ATT 3 - Draft Ball Road-Disneyland Drive Intersection Enhancements

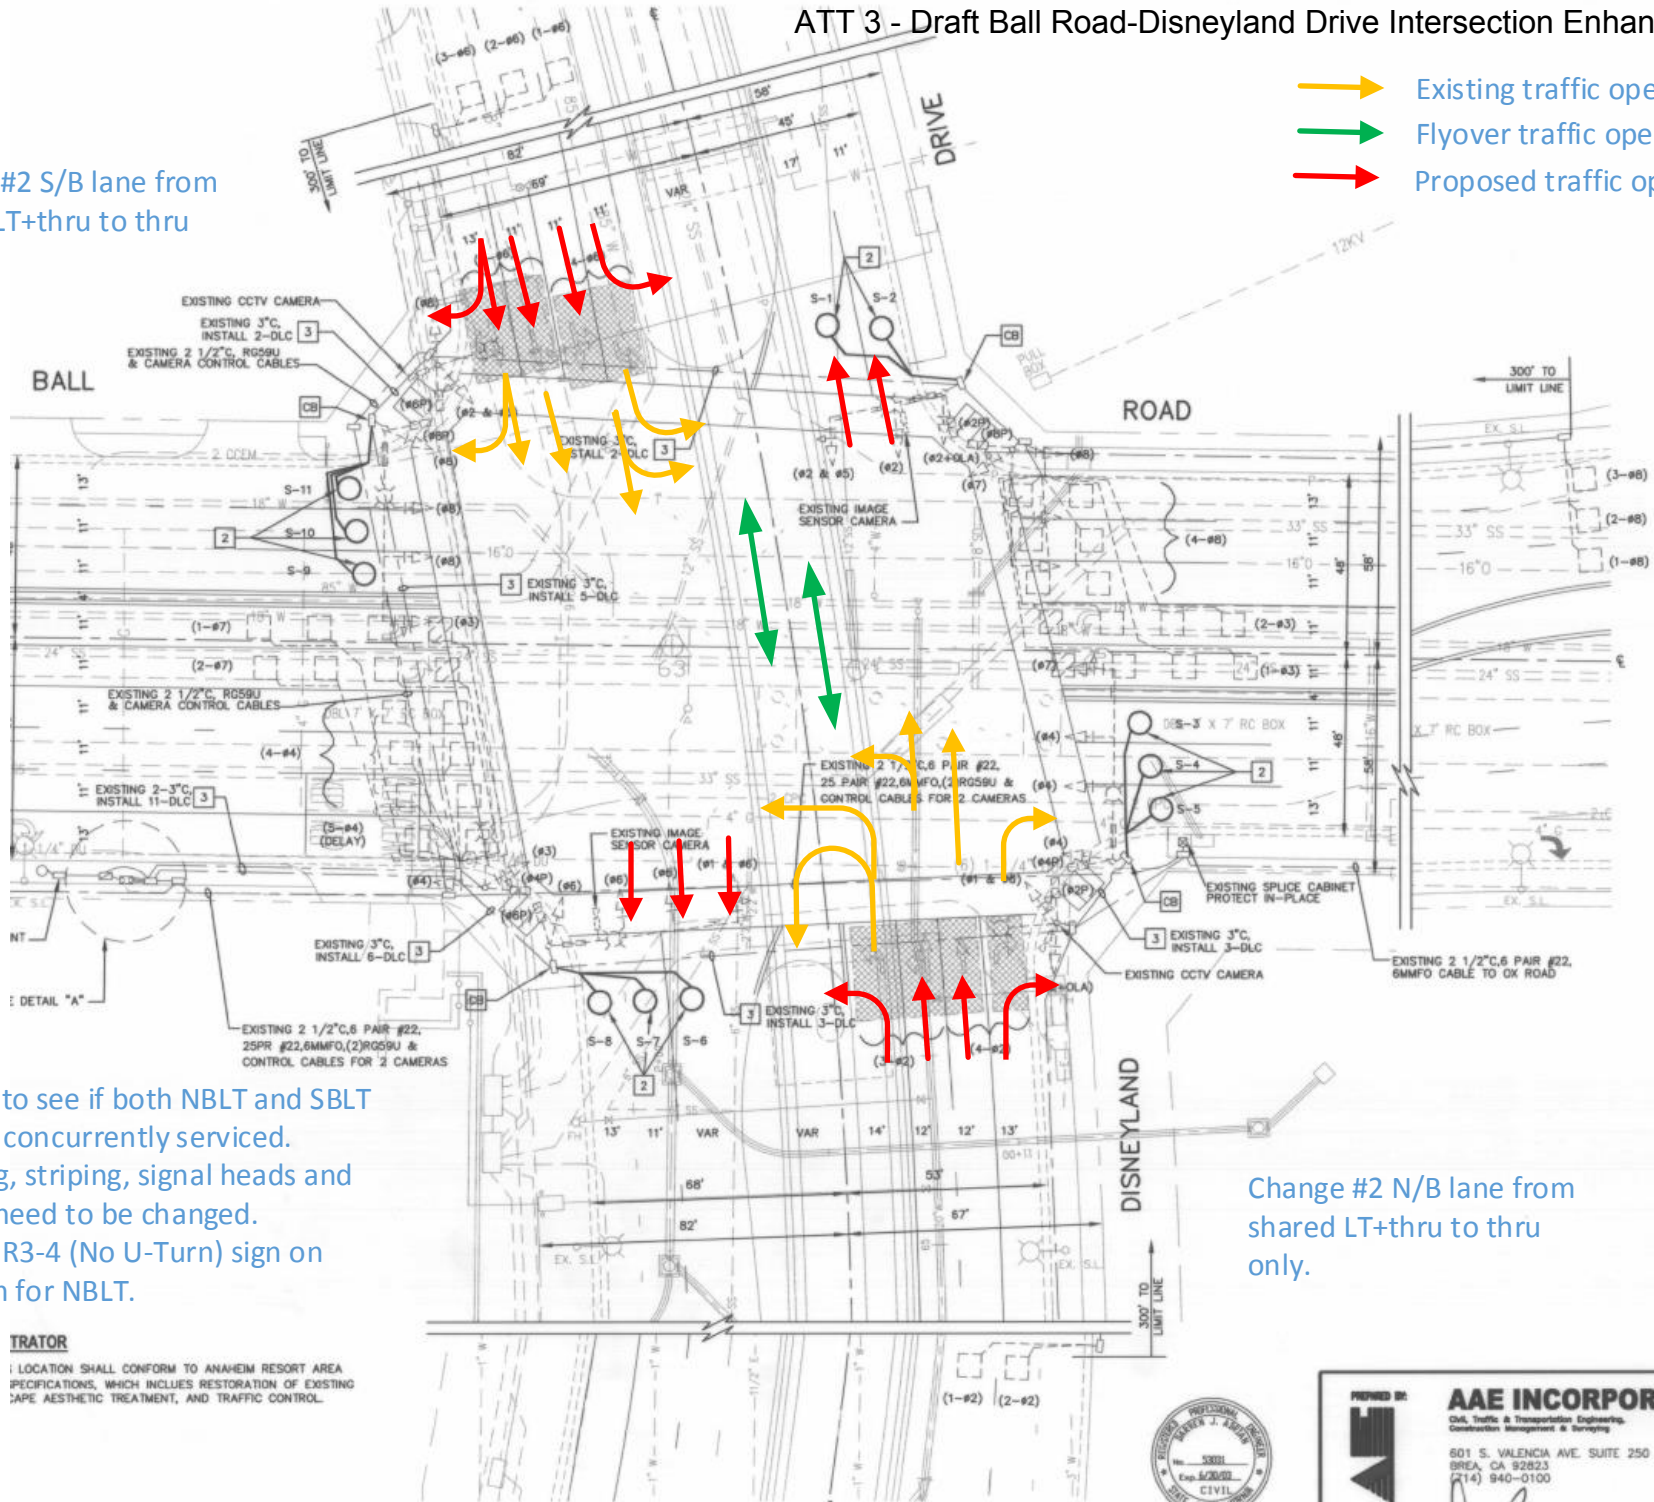
Change #2 S/B lane from shared LT+thru to thru only.

1. Check to see if both NBLT and SBLT could be concurrently serviced.
2. Signing, striping, signal heads and phasing need to be changed.
3. Install R3-4 (No U-Turn) sign on mast arm for NBLT.

Change #2 N/B lane from shared LT+thru to thru only.
